## RESPONSE TO REQUEST FOR ADDITIONAL INFORMATION

### APR1400 Design Certification

Docket No. 52-046

RAI No.: 100-8008  
SRP Section: 09.05.06 – Emergency Diesel Engine Starting System  
Application Section: 9.5.6  
Date of RAI Issue: 07/22/2015

Figure 9.5.6-1 Emergency Diesel Engine Starting Air System Flow Diagram

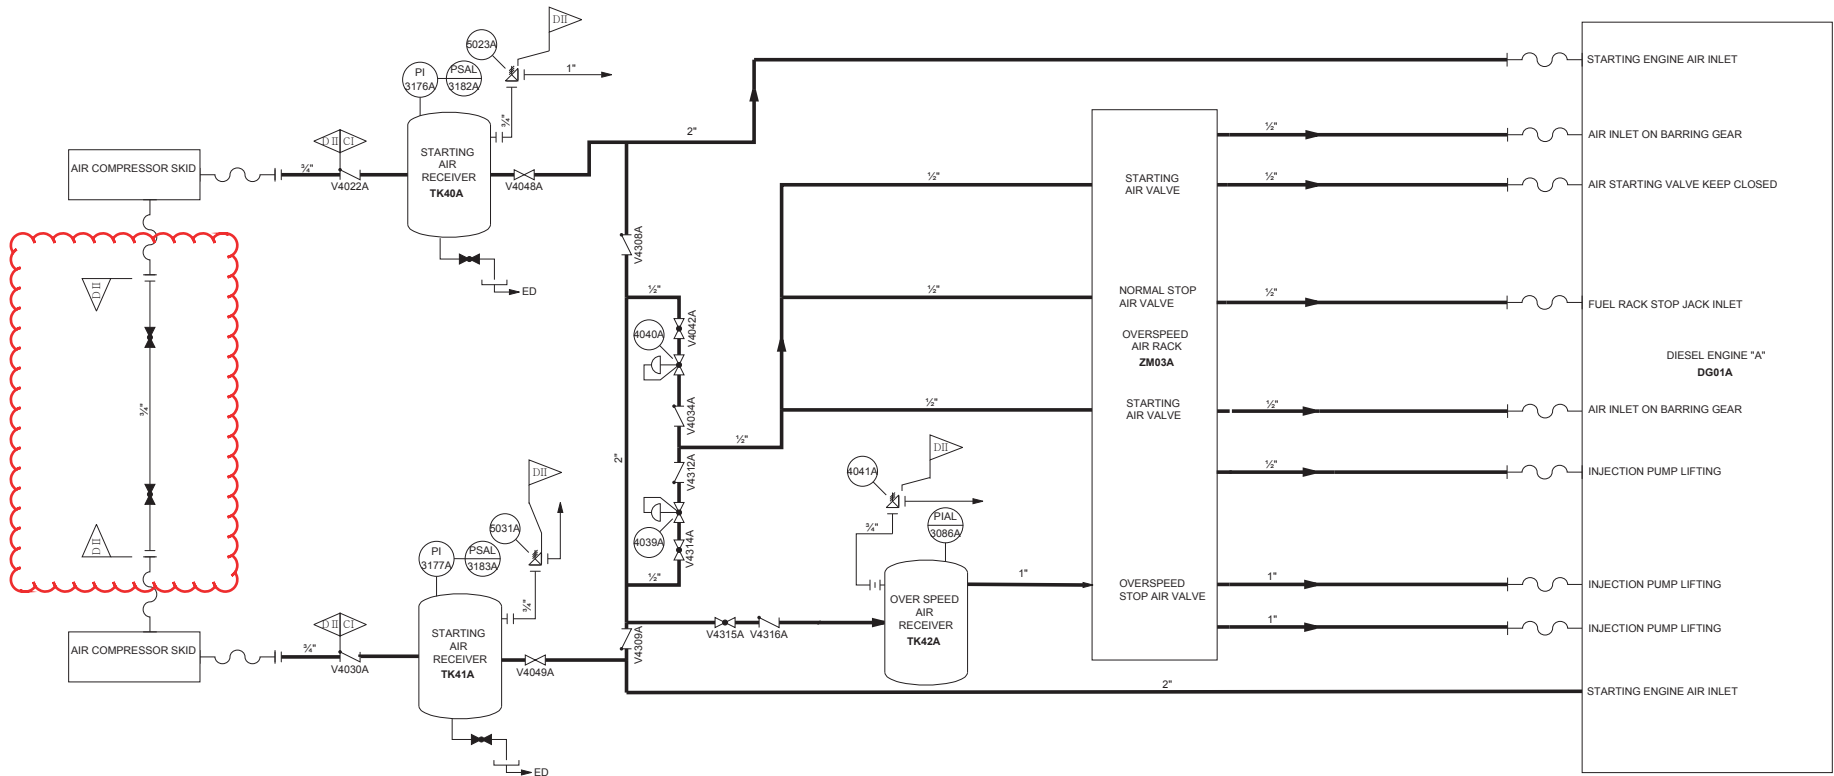
Figure 9.5.6-1 shows the cross-connecting line, but does not show any normally closed valve to isolate the redundant starting air systems.

The applicant is requested to provide the description and location of the normally closed valve and update figure accordingly.

The cross-connecting line with normally closed valves is located in the motor-driven compressor package. This cross-connecting line is marked on the attached markup, page 1 of 2.

Revised description : The EDESS consists of two redundant sets of equipment, each completely independent of the other for successful operation. The set of equipment consists of a motor-driven compressor package, an air receiver, valves, instrumentation and control system, piping, and devices to crank the engine. A cross-connecting line with a normally closed valve is provided between the two motor-driven compressor packages.

Figure 2.6.2-1 Emergency Diesel Generator Mechanical System

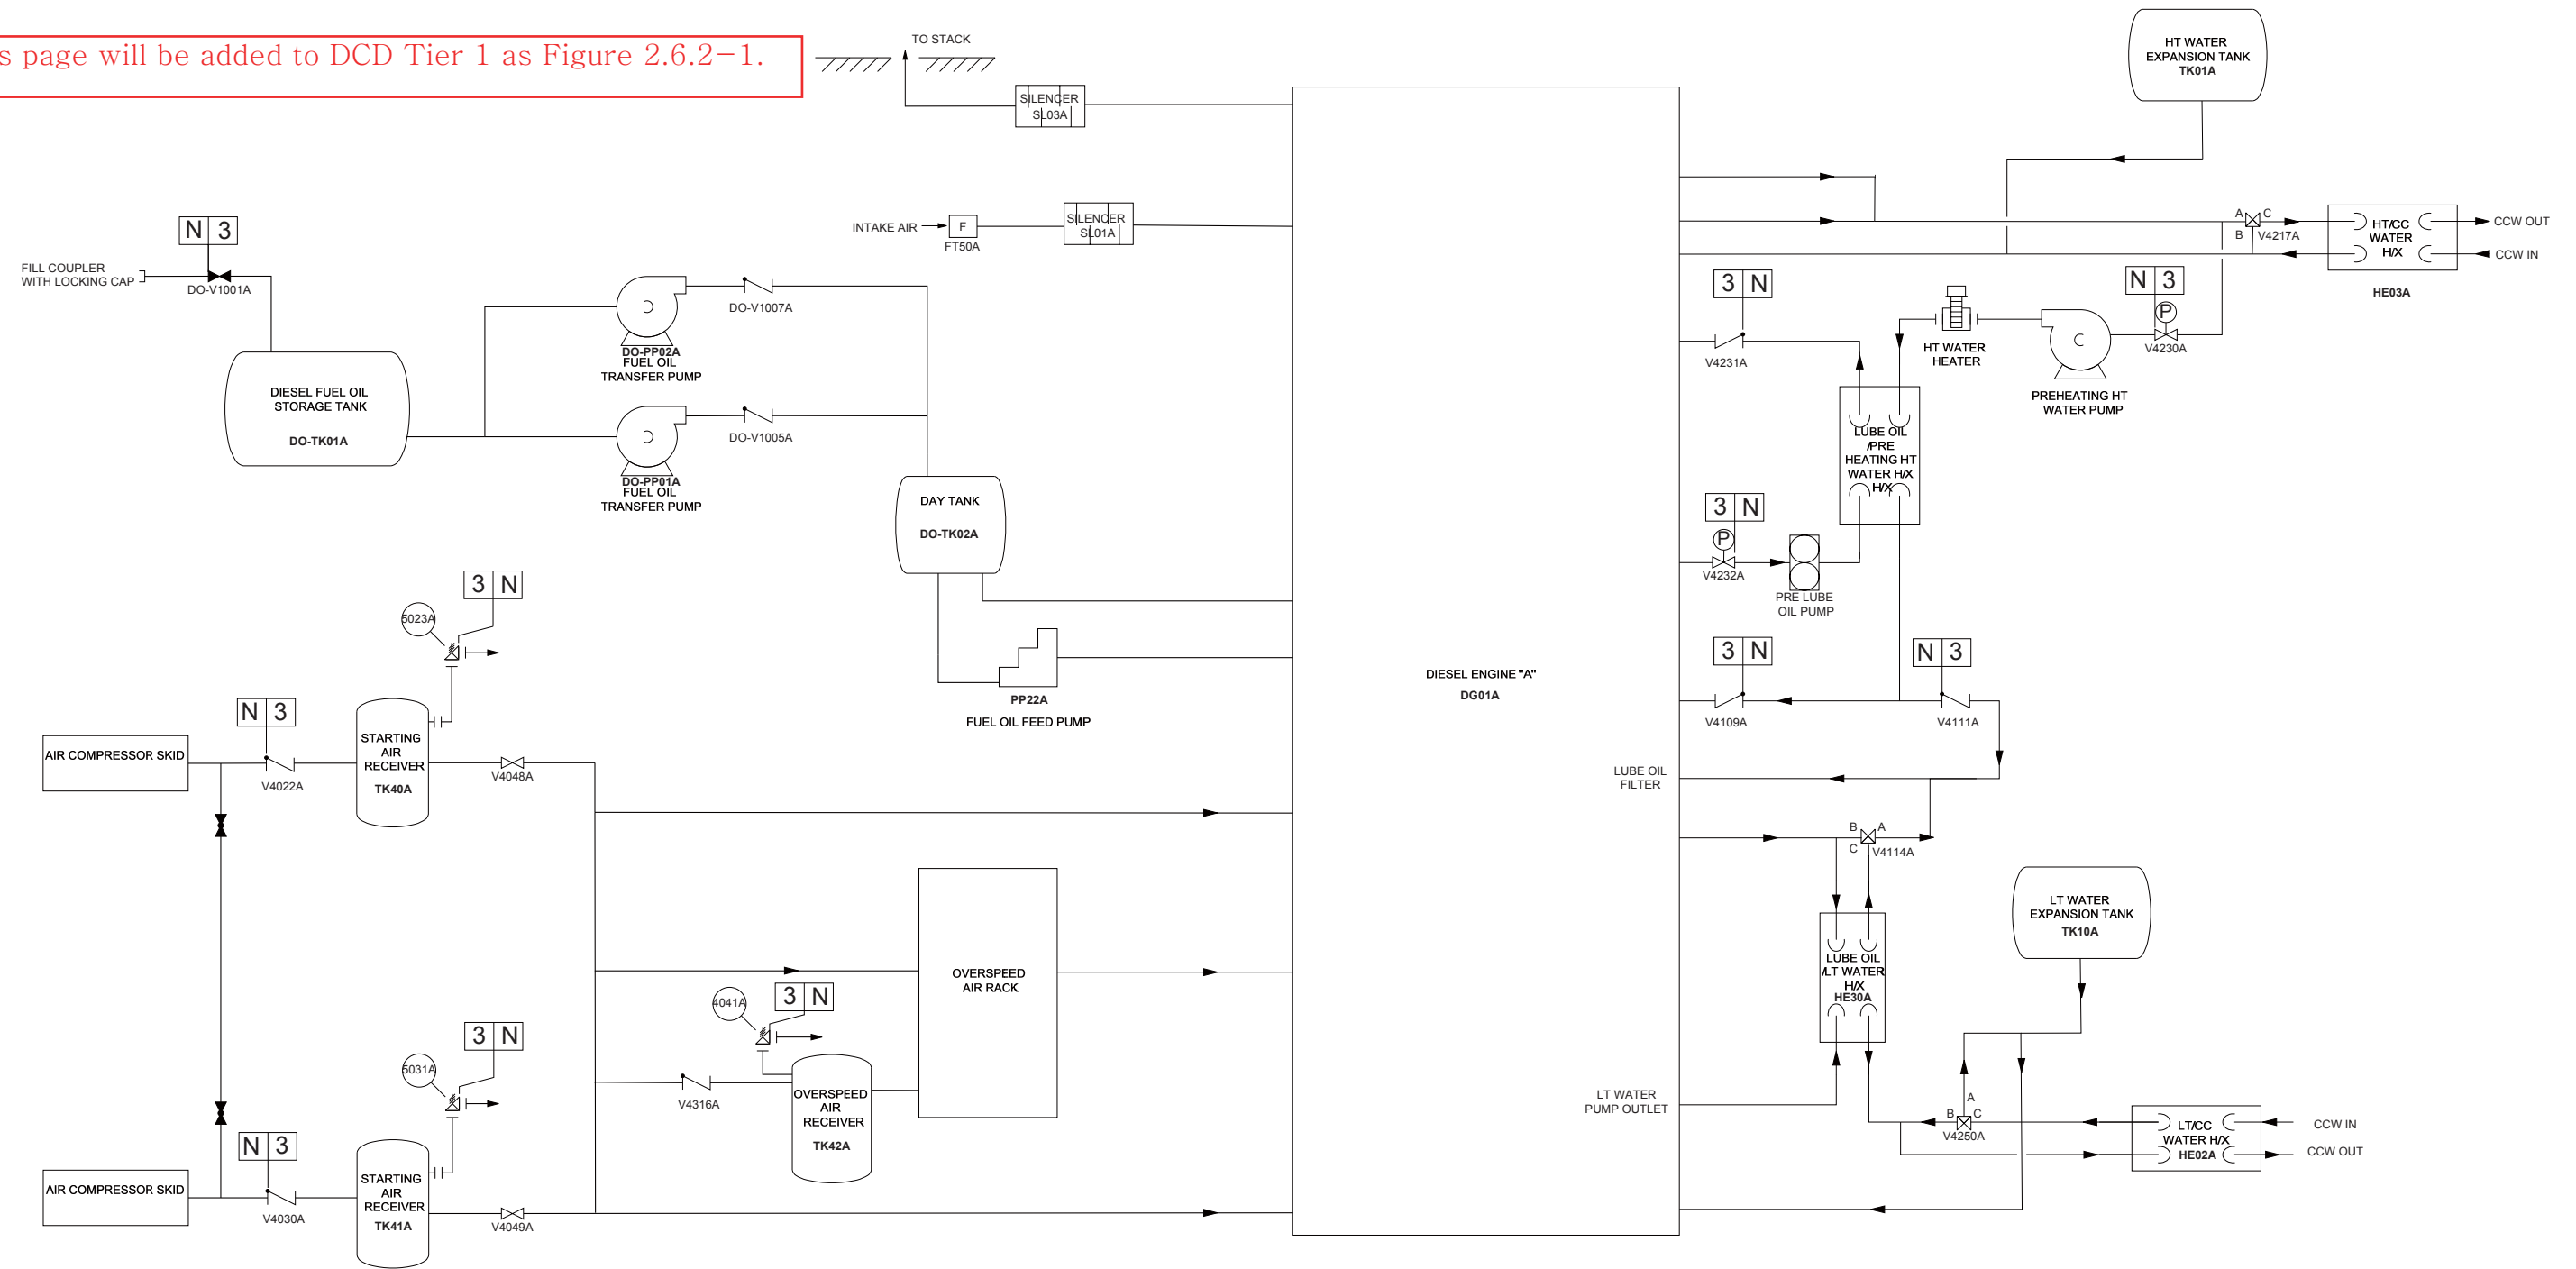
The staff finds that Tier 1 information does not include any figures for the safety-related EDG support systems to accompany the ITAAC to verify as-built functional arrangement. Also, Tier 2 contains flow diagrams in Section 9.5 and these details are not consistent with these Tier 1 tables.

The applicant is requested to consider adding support system diagrams to Tier 1 information in order to properly address ITAAC, as well as making Tier 2 Section 9.5 information consistent with corresponding Tier 1 information. (This RAI also applies to other EDG support system Section 9.5.4, 9.5.5, 9.5.7, and 9.5.8)

The figure on the EDG mechanical system will be added to DCD Tier 1 as Figure 2.6.2-1.

This page will be added to DCD Tier 1 as Figure 2.6.2-1.
